SUPPLEMENTAL RESPONSE TO REQUEST FOR ADDITIONAL INFORMATION

APR1400 Design Certification

RAI No.: 160-8174

SRP Section: 09.03.04 – Chemical and Volume Control System (PWR) (Including Boron Recovery System)

Figure 9.3.4-1 Chemical and Volume Control System Flow Diagram (1 of 7)

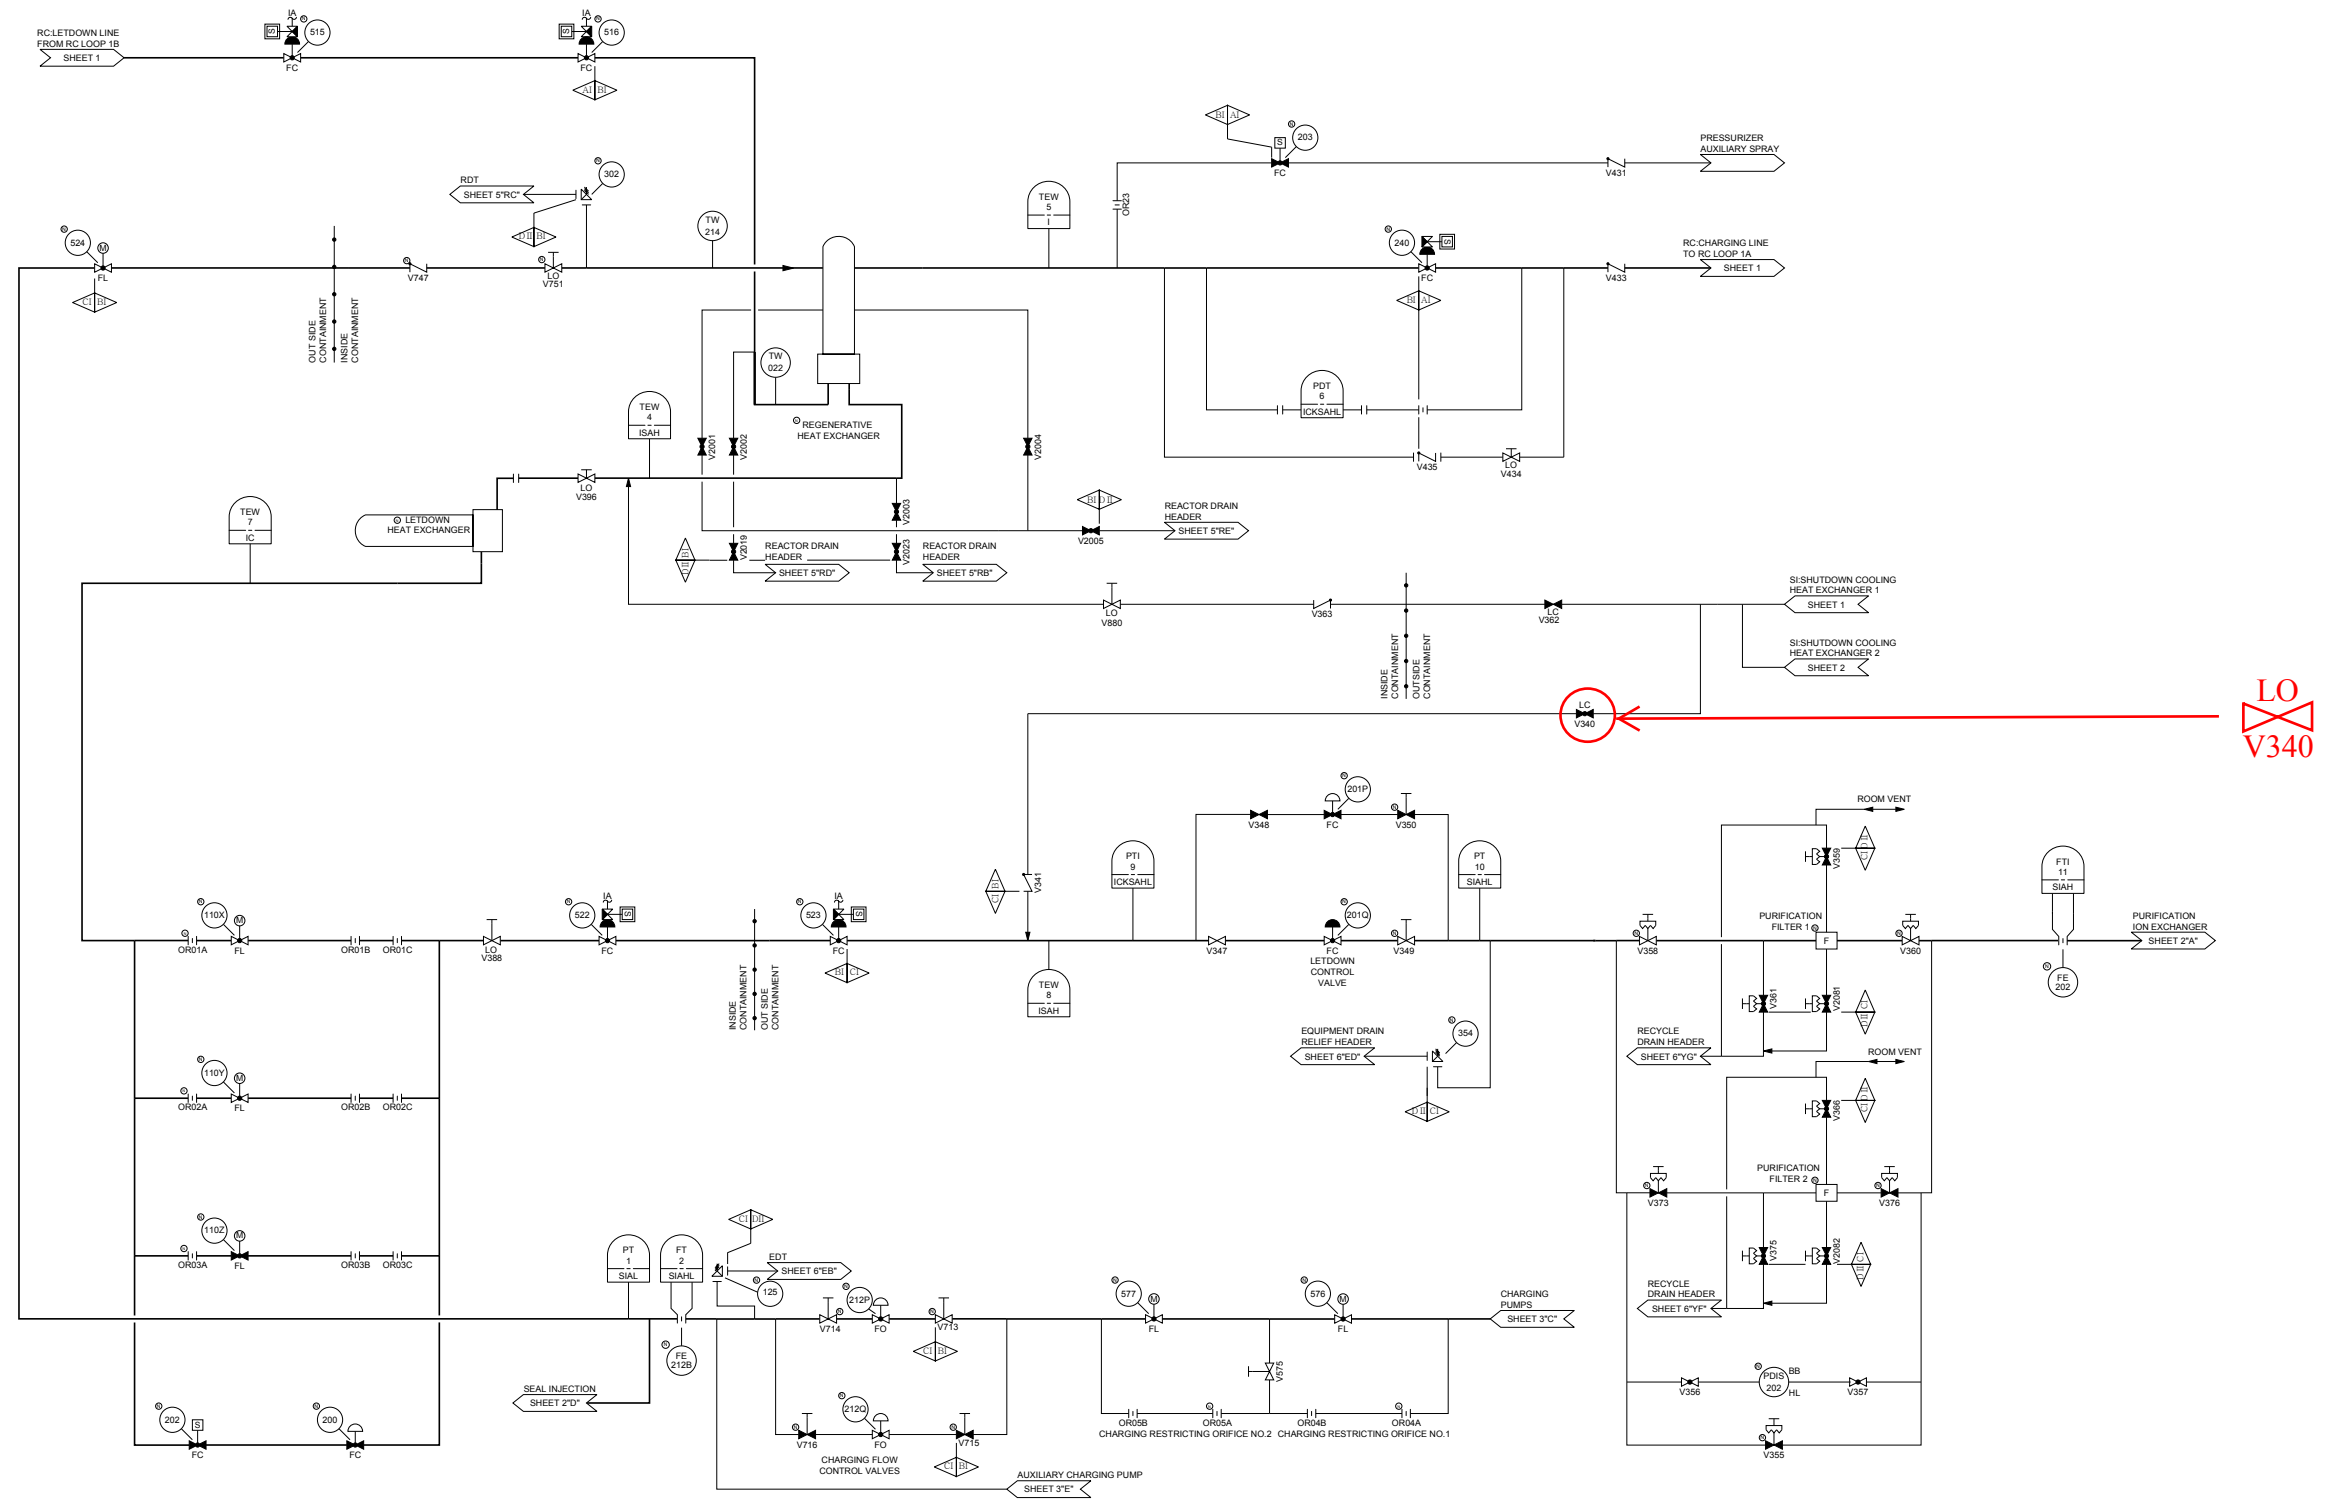
In regards to the applicant's response to RAI 160-8174, Question 09.03.04-6, the applicant provided a satisfactory response regarding updating Tier 1 to be consistent with Tier 2 for valve CV-362. During the staff's review of the Attachment to Question 09.03.04-6, the staff noted that CV-340 of DCD Tier 1, Figure 2.4.6-1 is also inconsistent with DCD Tier 2, Figure 9.3.4-1. The staff would like to discuss with the applicant a means for correcting this inconsistency and determining if other inconsistencies like this are in the applicant's DCD.

CV-340 is a normally open valve. DCD Tier 2, Figure 9.3.4-1 (Sheet 1 of 7) will be revised as shown in Attachment 1. But because CV-340 is not subject to CVCS ITAAC (not included in DCD Tier 1, Table 2.4.6-2), the detailed information on the valve such as the locking status does not need to be shown in DCD Tier 1, Figure 2.4.6-1.

DCD Tier 2 Figure 9.3.4-1 will be revised as presented in Attachment 1.
DCD Tier 1 Table 2.4.6-1 and Figure 2.4.6-1 will be revised as presented in Attachment 2.
